Access Compliance Report

Public Rights-of-Way

(Curb Ramps)

Intersection ID: 30558	Main Street: GREENCREEK_DR	Cross Street: WANDERING_BROOK_DR	Location: W
ADA ID: 6442A7A00A14	Ramp Type: PerpDiag	Initial Pass/Fail: Fail	Overall Compliance: No
Severity Score: 25			
Codes/Mitigation Info/Possible Solution		Field Measurements/Component Compliance

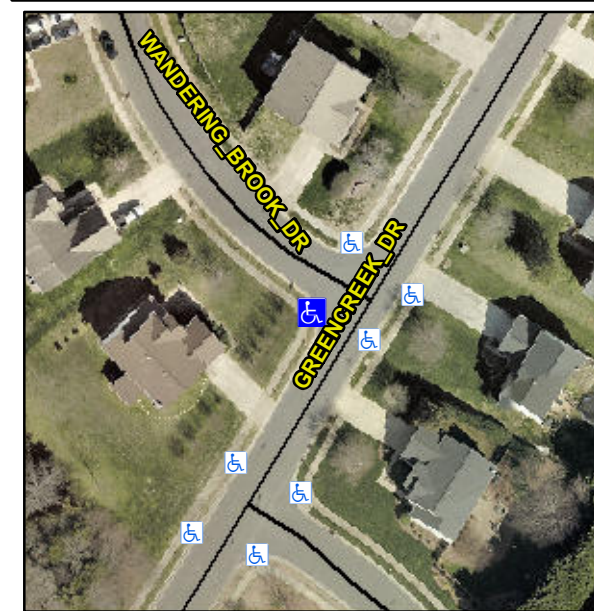
Not Found, R304.5.3

Compliance	Description	Data	Compliance	Description	Data
N/A	Ramp Length (in)	95.0	Yes	Ramp Slope (%)	5.3
Yes	Ramp Width (in)	48.0	No	Ramp XSlope (%)	8.0
N/A	Flare Type LT	N/A	N/A	Flare Type RT	N/A
N/A	Flare Slope LT (%)	N/A	N/A	Flare Slope RT (%)	N/A
N/A	Flare Traversable LT?	N/A	N/A	Flare Traversable RT?	N/A
N/A	Landing Length (in)	N/A	N/A	DWS Provided?	N/A
N/A	Landing Width (in)	N/A	N/A	DWS Contrast?	N/A
N/A	Landing Slope (%)	N/A	N/A	DWS Length (in)	N/A
N/A	Landing X Slope (%)	N/A	N/A	DWS Full Width?	N/A
N/A	Landing Curb? (Y/N)	N/A	N/A	DWS Offset (in)	N/A
N/A	Shared Landing?	N/A			
N/A	Gutter Ponding?	N/A	N/A	Gutter Slope (%)	N/A
N/A	Gutter Lip Ht (in)	N/A	N/A	Gutter X Slope (%)	N/A
N/A	Painted X Walk1?	No	N/A	Painted X Walk2?	No
	X Walk 1 Direction	To SE		X Walk 2 Direction	To NE
N/A	X Walk 1 Width (in)	N/A	N/A	X Walk 2 Width (in)	N/A
	X Walk 1 Slope (%)	0.9		X Walk 2 Slope (%)	4.7
	X Walk 1 X Slope (%)	4.3		X Walk 2 X Slope (%)	0.9

Remove & Replace Curb Ramp With Two New Directional Ramps or Equivalent.
